Item Name: Lower Door Assembly, RH

D4467-041 LOWER DOOR ASSY (LH)

DRAWING NO. D4467	TITLE LOWER DOOR ASSY	REV. D	DART AEROSPACE LTD ENGINEERING ORDER	D.E.O. NO. D4467-D-1	SHEET NO. SHEET 1 OF 2	SCALE NTS
DRAWN AJS	CHECKED AP	MFG. APPR. DD	APPROVED HS	DE APPR. HS		
DATE 15.05.20	DATE 15.05.27	DATE 15.05.27	DATE 15.05.27	DATE 15-05-27

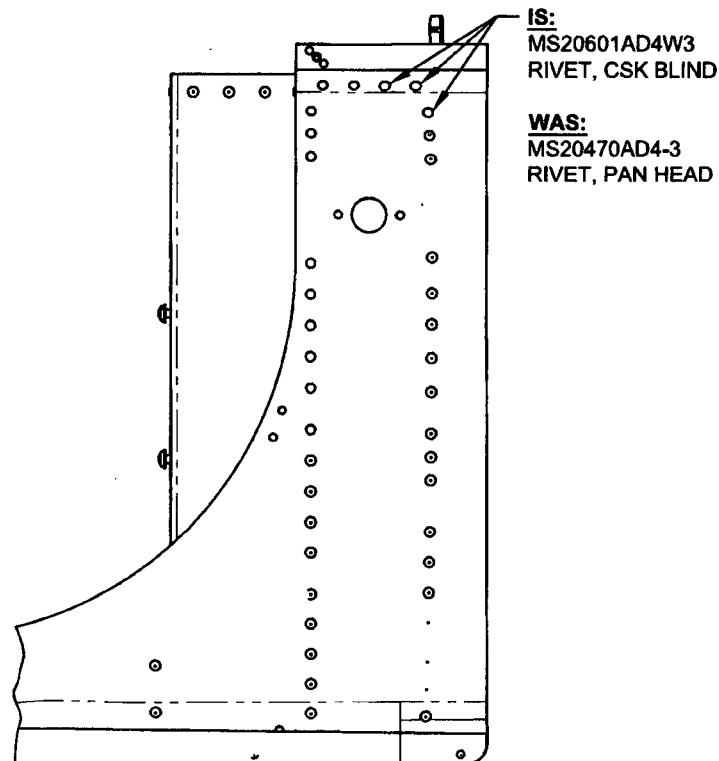
SEE SHEET 2 ZONE C1 AND SHEET 7 ZONE C8 CHANGE THE RIVETS SHOWN FROM PAN HEAD TO COUNTERSUNK AS SHOWN BELOW:

SECTION B-B
(SCALE 1.25X)

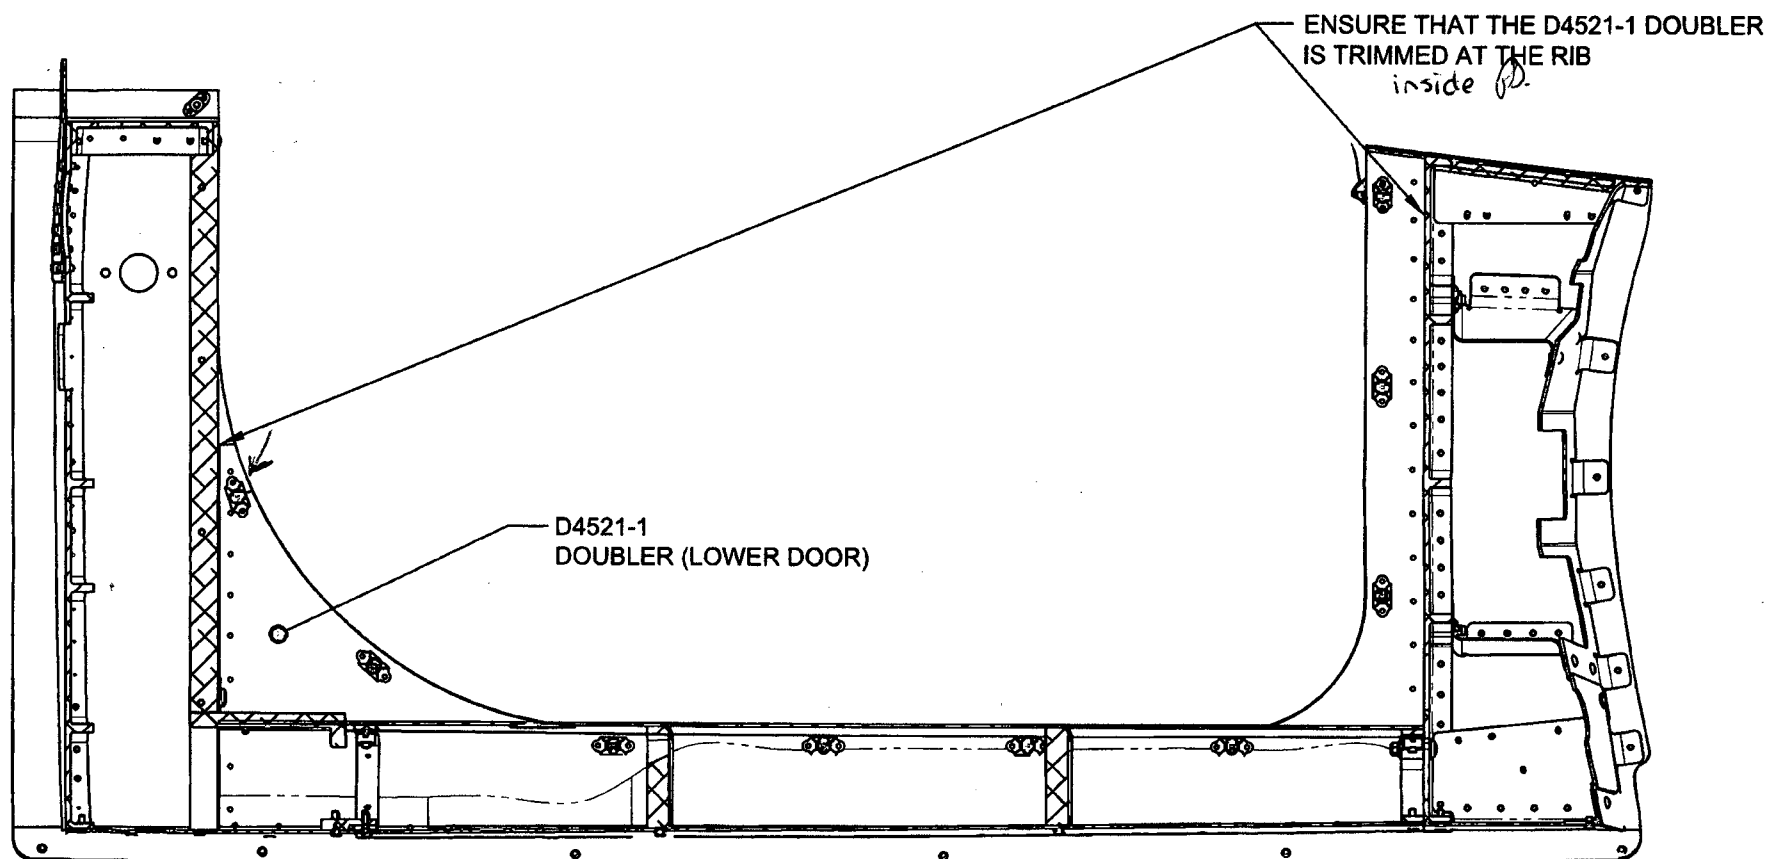
ON SHEETS 5 AND 10, ADD THE NOTE BELOW TO SECTIONS B-B AND SECTION F-F.
